Attachment 13 - DEP Comments and Applicant's response

DEP

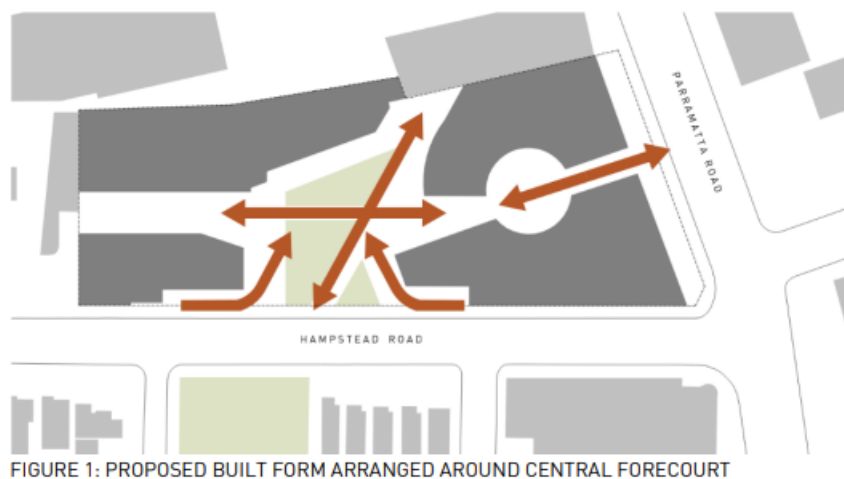
The front entry to the building is poorly resolved with the entry axis from the street terminating in a door accessing toilets.

Spatially the site has been arranged around a central forecourt, featuring landscaped park areas, a large dining zone and designed to allow for future cross site links to Parramatta Road along the stormwater easement. This forecourt acts as a welcoming public space, drawing people into the proposed shopping, dining and office precinct. Both buildings have been designed to address this central forecourt, with the front entrance to the stage 2 building designed as a large angled opening welcoming people from the forecourt into the central atrium of the Stage 2 building. Walking in either direction on Hampstead Road, direct lines of sight are provided to either the Stage 1 or Stage 2 building entries.

The development steps back from the street in approach to this forecourt, allowing for a covered colonnade which acts as a widening of the existing footpath and increasing permeability of the site. The entry space to the toilet block has been redesigned to align with the adjacent cafes, allowing the entryway to blend into the development and increasing the forecourt area.

The below diagram highlights the arrangement of the built form around the central forecourt, which is intended to act as the main focal point of the site. The forecourt is proposed to draw people into the shopping and dining precinct increasing activation within the area.
